UNITED STATES PATENT AND TRADEMARK OFFICE

APPLICATION NO.	FILING DATE	FIRST NAMED INVENTOR	ATTORNEY DOCKET NO.	CONFIRMATION NO.
10/765,636	01/27/2004	Gerald R. Savicki JR.	905P164	2271
44564	7590	03/09/2005	EXAMINER	
BOND, SCHOENECK & KING, PLLC 10 BROWN ROAD, SUITE 201 ITHACA, NY 14850-1248			KLAUS, LISA NHUNG	
			ART UNIT	PAPER NUMBER
			2832

Office Action Summary

DETAILED ACTION

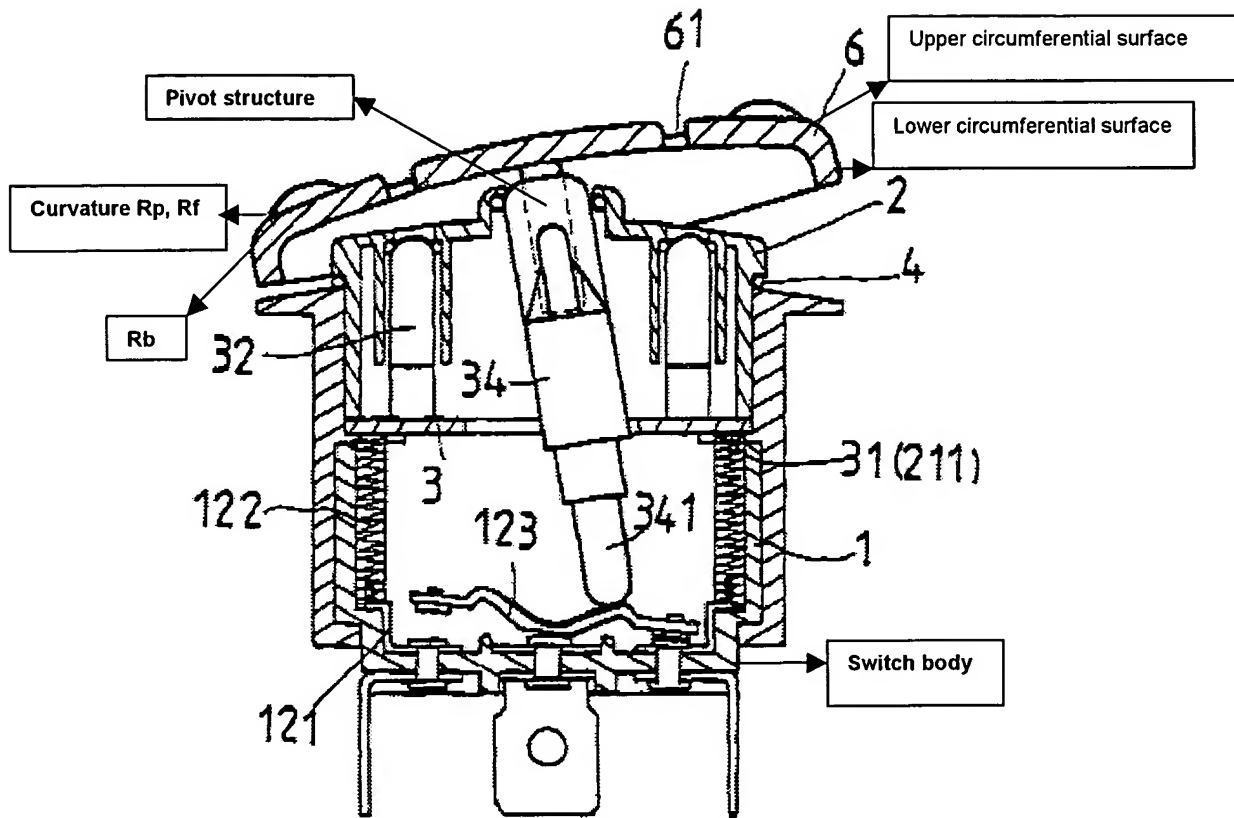
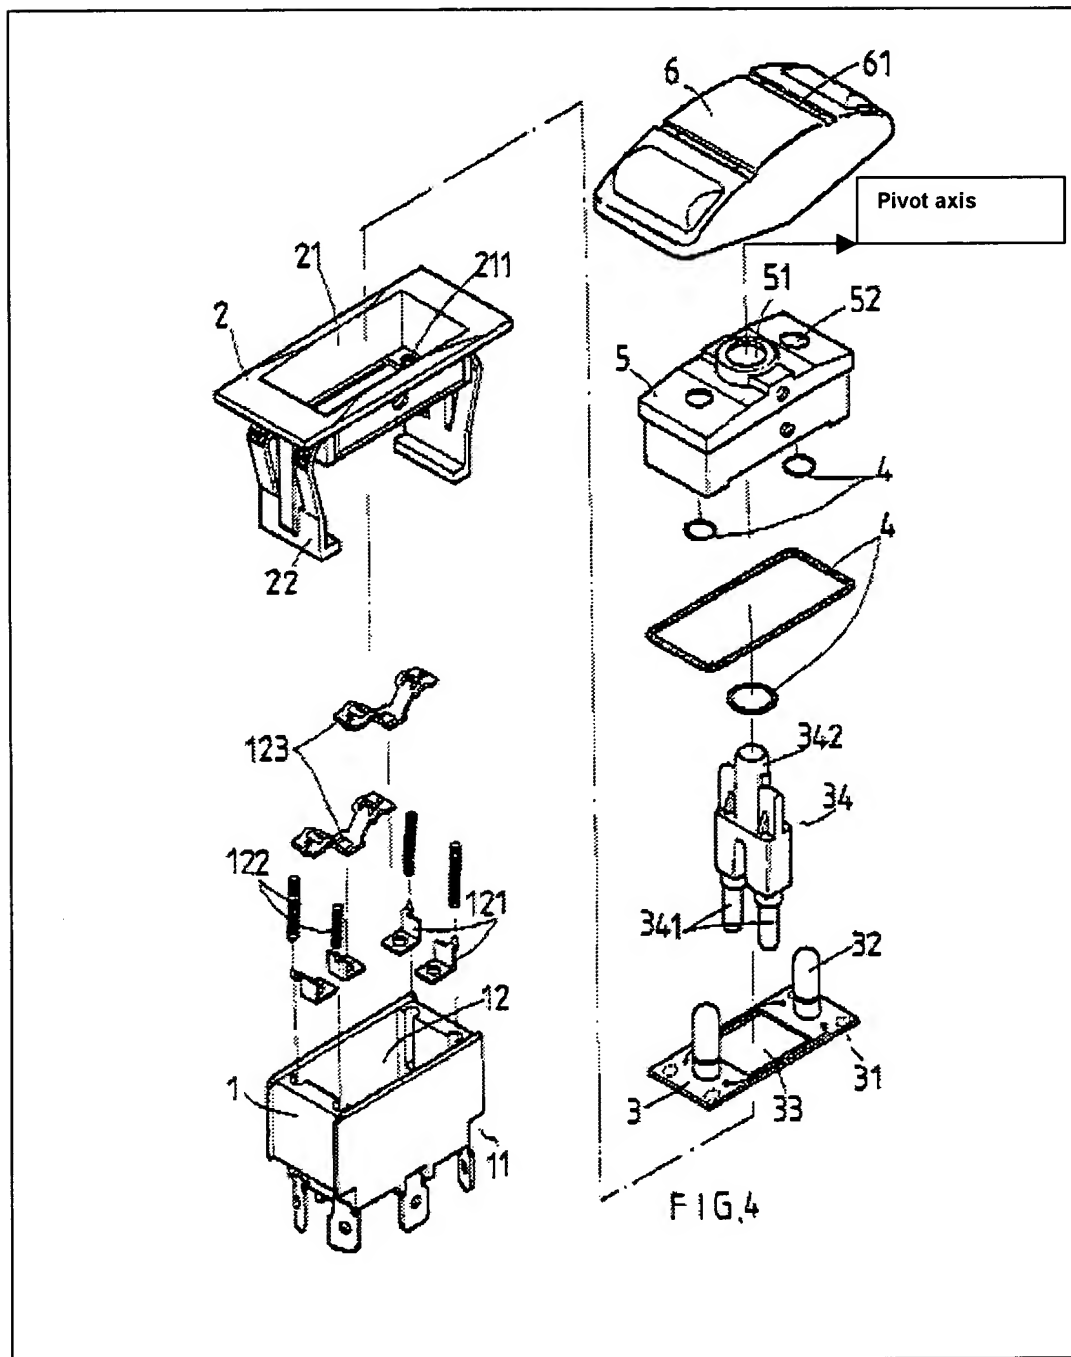
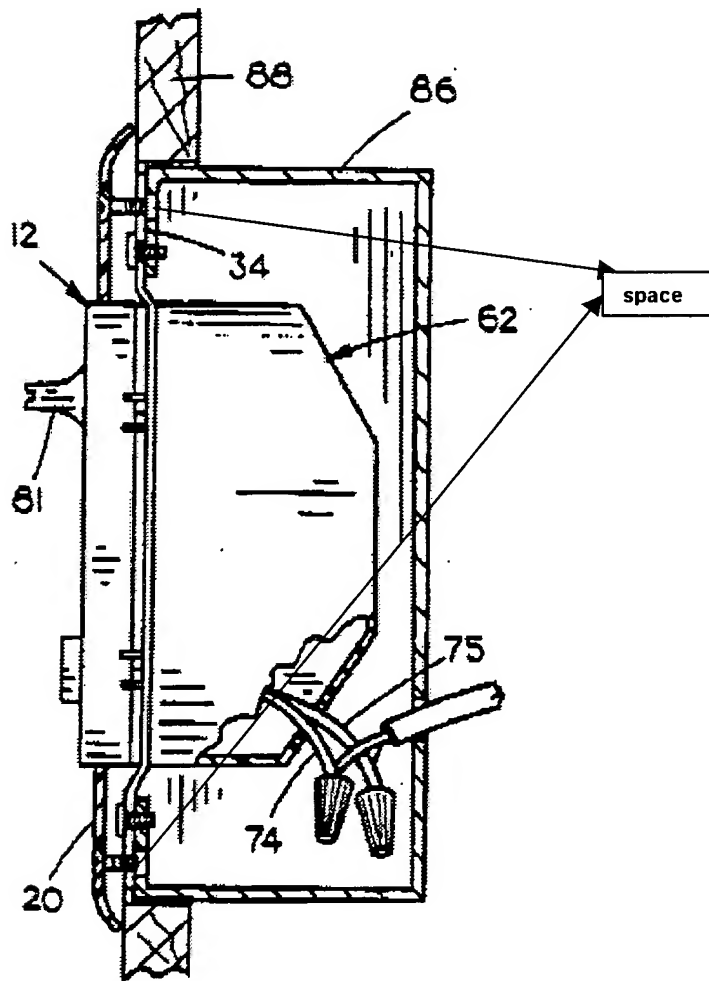
- a switch body 1 including switch contact (see attachment);
- a frame 5 attached to the switch body;
- a paddle 6 for actuating the switch contacts;
- wherein the paddle has a pivot structure cooperatively engageable with a portion of the frame for selective rotational movement around a pivot axis (see the attachment) between a limited forwardly-tilted position and a limited rearwardly-tilted position;
- wherein the paddle has a uni-convex cylindrical exterior surface with a curvature, R_p (see the attachment);
- the paddle 6 has an actuating structure integrally attached to a rear surface thereof having a distal end that operationally enables an open-switch condition and a closed-switch condition;
- the paddle 6 has an upper and a lower circumferential surface (see the attachment) each having a curvature, R_b , the center of which originates along the pivot axis;

Yei further comprises the paddle 6 includes an upper and a lower circumferential surface having a curvature, Rb (see the attachment), the center of which originates along the pivot axis.

- a mounting strap 34 attached to the switch body 62;
- one of the upper and the lower circumferential surfaces 20 engages a space (see the attachment) intermediate a portion of the mounting strap 34 and a surface of the frame 86 in one of the forwardly-tilted position and the rearwardly-tilted position;
